PE05-067
HEIL TRAILER
12/19/2005
EXHIBIT 1, 2, 3, 4, & 5
PART 1 OF 3

TECH SERVICE FIELD REPORT

Re: Pull Trailer Frame Improvement

Subject: [REDACTED] UNIT 275 HEIL SERIAL # 67750

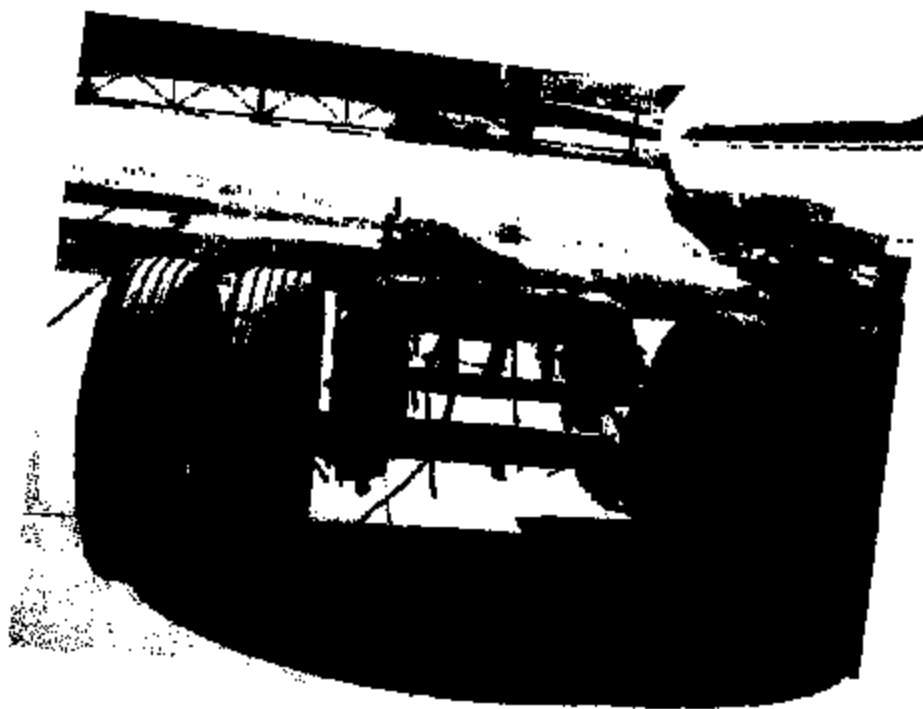
Both ██████████ have had a pull trailer that the front suspension and axle separated from the frame. These separations occurred as the drivers pulled away from a stop. The ██████ driver stopped before the trailer actually dropped on the ground the Dandee driver didn't and the trailer landed on it's nose. It didn't leak but damaged the hose tubes, ladder, and the hose tube cabinet box put a deep scratch on the front head.

All of the failures have occurred on air ride California pull trailers, just to the rear of the front air ride tower. The crack started at the bottom of the frame tube and travels up.

DAVID HERE ARE THE PICTURES OF THE DANDEE UNIT

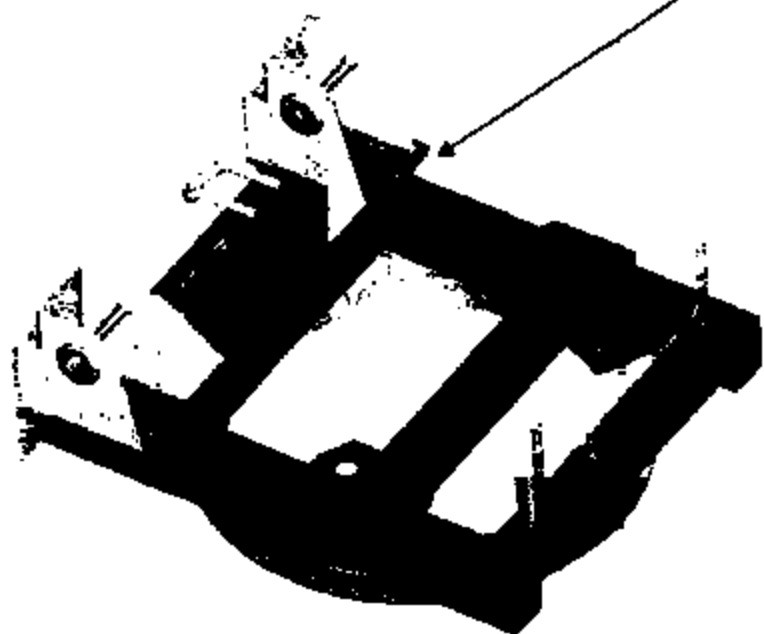
**Mark plate at
 $\frac{3}{4}$ in from end.
Both Sides.**

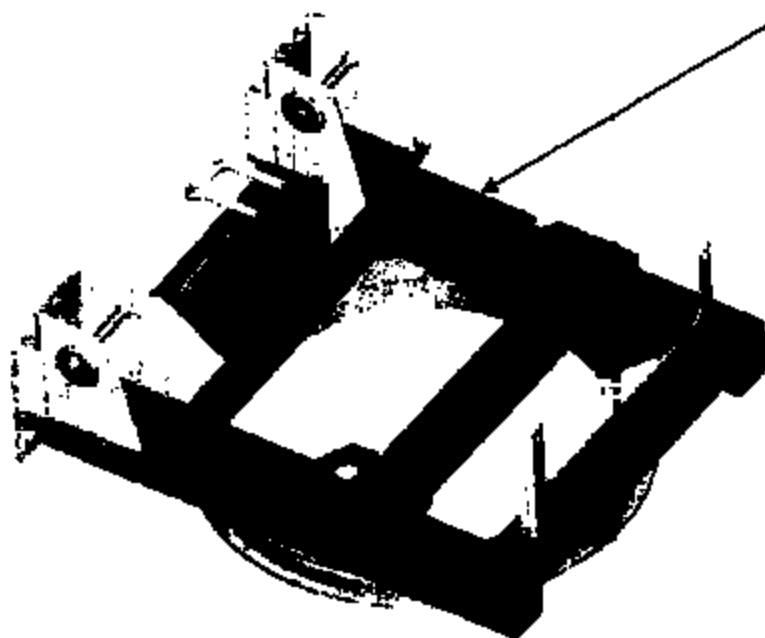
**Cut and remove end
of plate at mark.
Both Sides.
Grind off existing
weld.**

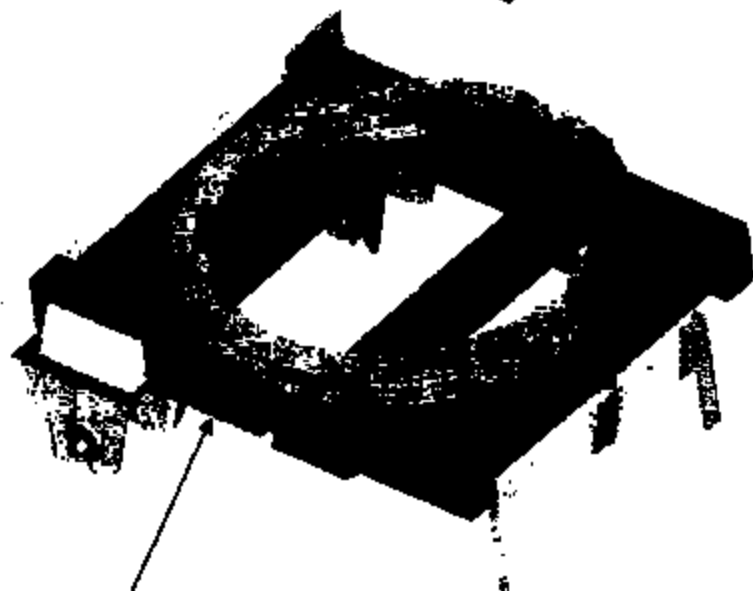
Locate 5in X 12in X
 $\frac{1}{4}$ in steel bar on
frame rails.
Both Sides.

Weld, length-wise.

Both Sides.

(4) Places, total.

Weld the new plate to the existing mounting plate
for the suspension tower.

DO NOT Weld across the frame rail.
